Sub: Modification Sheet No. RDSO/2017/EL/MS/0465 Rev.'0' Dated 18.10.2017

Modification Sheet No. RDSO/2017/EL/MS/0465 (Rev. '0') dated 18.10.2017

1.0 Title: Modification in three phase electric locomotives for:

PROVISION OF TRAP CHAMBER IN BP CIRCUIT
IN 3 PHASE LOCOS WITH CCB VERSION

Photograph-2. Modified BP pipe line with trap Camber arrangement.

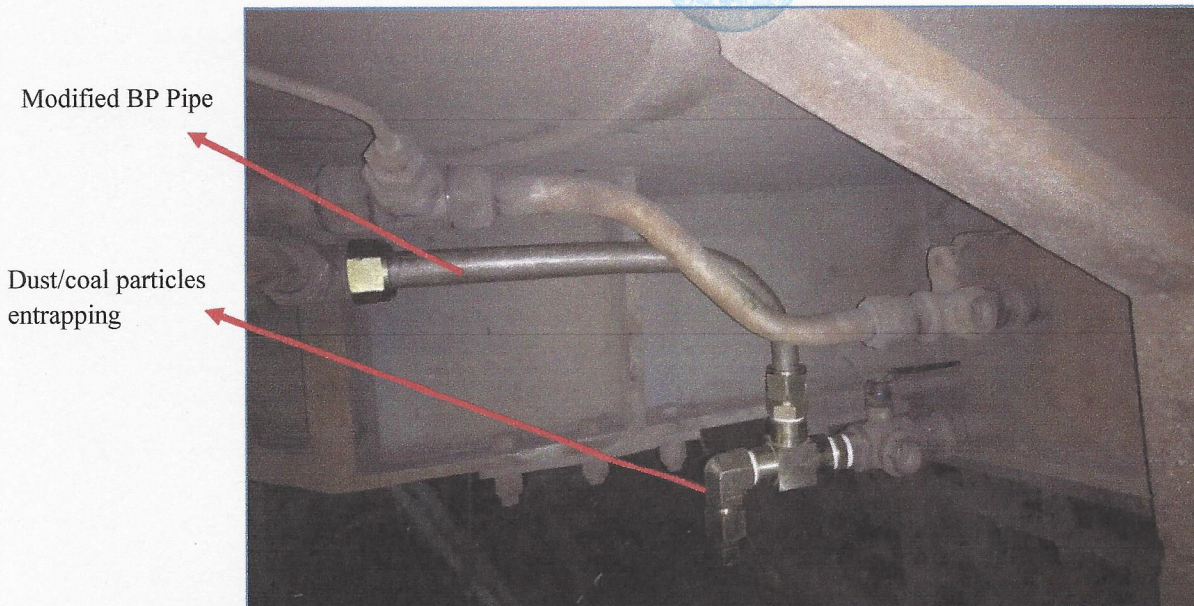
(1) Modified arrangement to trap coal/dust particles:-

Photograph -1. Existing BP pipe line arrangement without trap chamber arrangement.

- 1) Trap chamber modification to be done as per the enclosed drawing similar to that done in conventional electric locomotives vide RDSO Mod. No. RDSO/2017/EL/MS/0463 Rev'0' dt: 08-9-17. For this a T-joint is to be provided after additional BP cut out cock. The trap chamber/dummy to be connected on other side of the T-joint and the BP pipe line to be connected vertically at about angle of 90 to 120 degree. The arrangement of trap chamber is shown in photograph (2) under para No.6. This arrangement should be made in both cabs and applicable to all 3phase locos.

Trap chamber is to be opened during every IC/TOH/IOH/POH schedules for cleaning or replacement (if required).

Photograph-4. Provision of FTIL make EEV/ mod. Design NB-11 in CCB locos

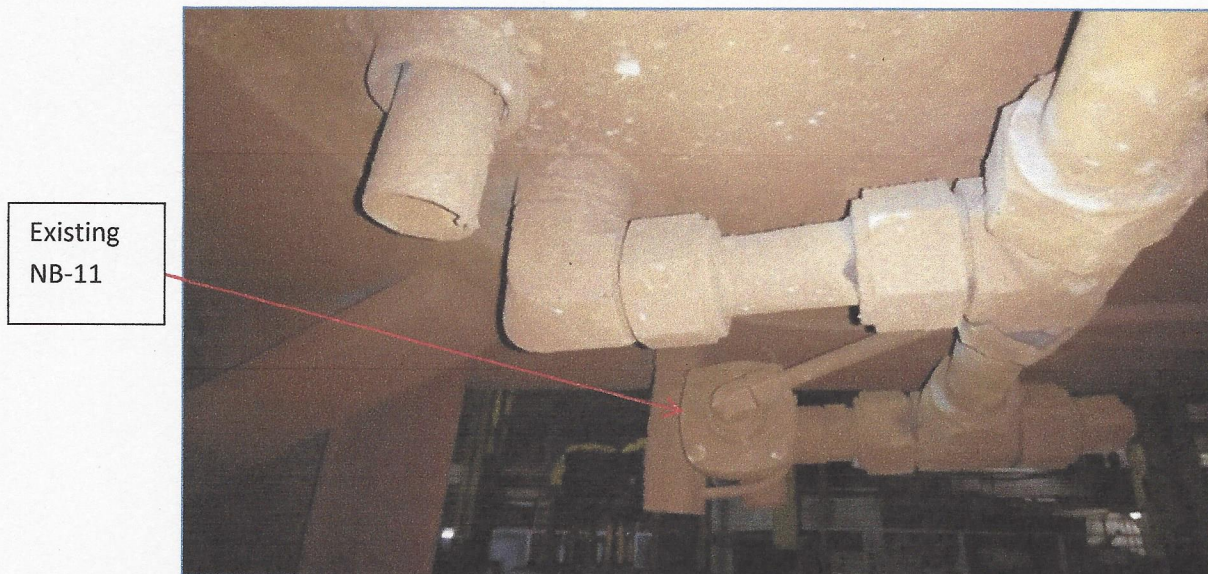
(2) Replacement of existing NB-11 valve with FTRTIL design EEV or similar design EEV

Photograph-3. Existing NB-11 valve in CCB brake system of M/s KBIL

- 2) The existing NB-11 valve (01" size) to be replaced with FTRTIL E70 design Emergency exhaust valve or similar design valve (1¼ " size) in CCB locos as shown in the photograph (4) under para no.6.0. This arrangement should be made in both cabs and applicable to locos fitted with CCB brake system. The valve should be fitted in such a way that inlet of pilot pressure should enter from top (vertically) into the valve as shown in photograph no-6.

Photograph- 6. FTRTIL make 1 ¼" EEV

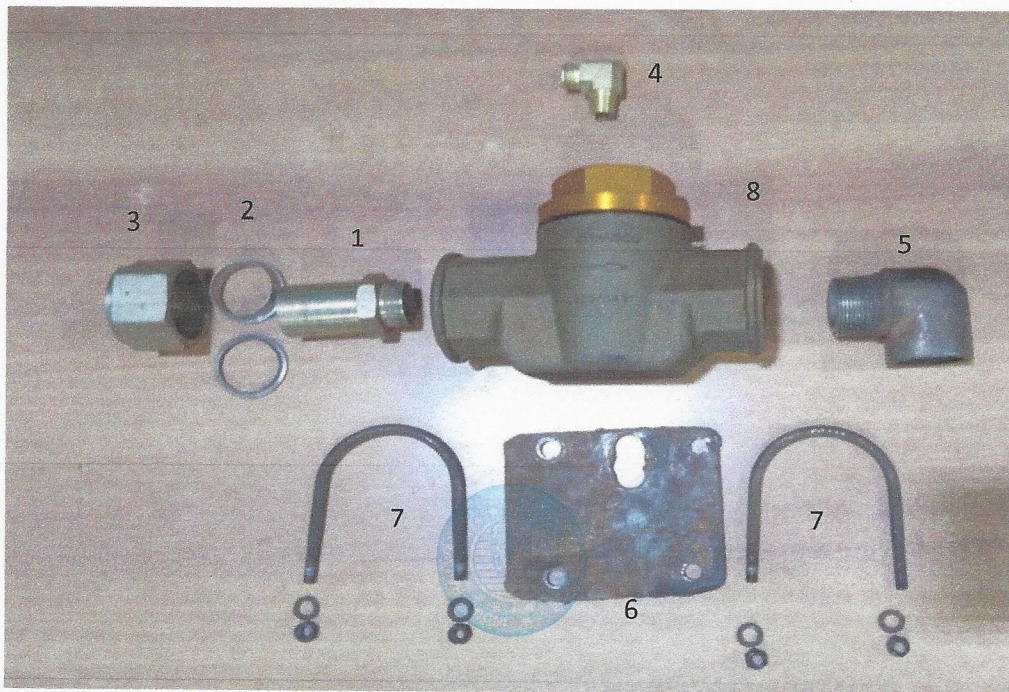
5.2) Material required for provision of FTIL make 1 ¼ " emergency exhaust valve in place of existing NB- 11 valve.

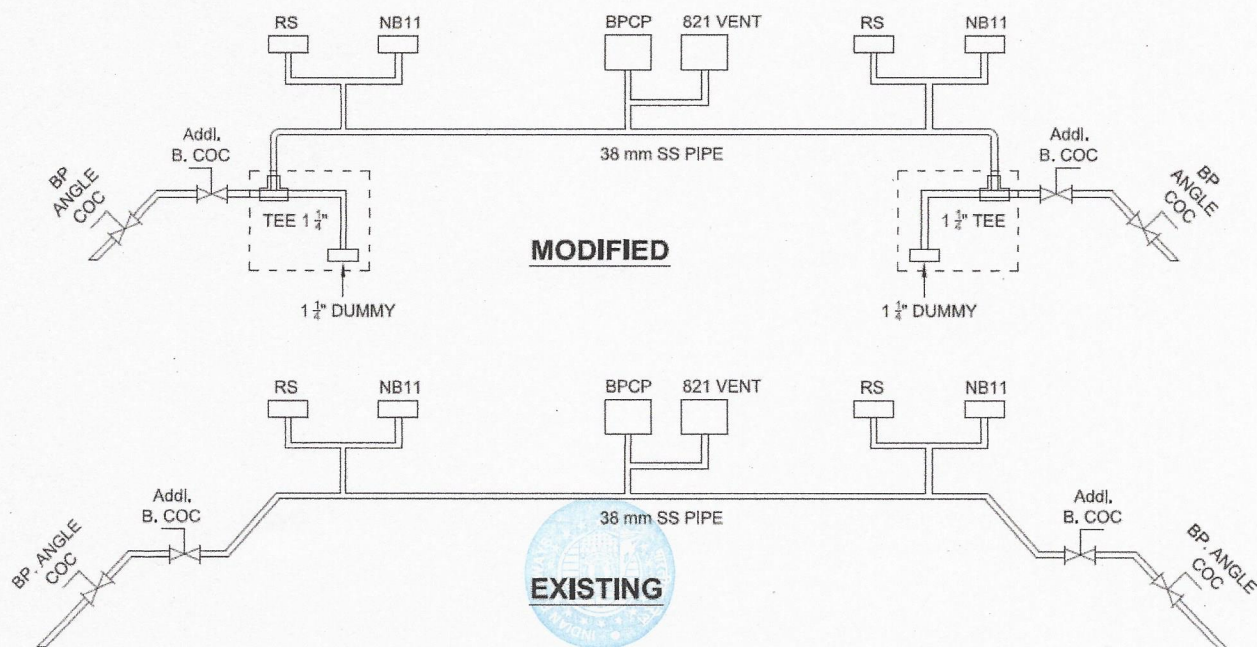
Annexure to Modification Sheet No. RDSO/2017/EL/MS/0465 Rev 'O' dated 18.10.2017
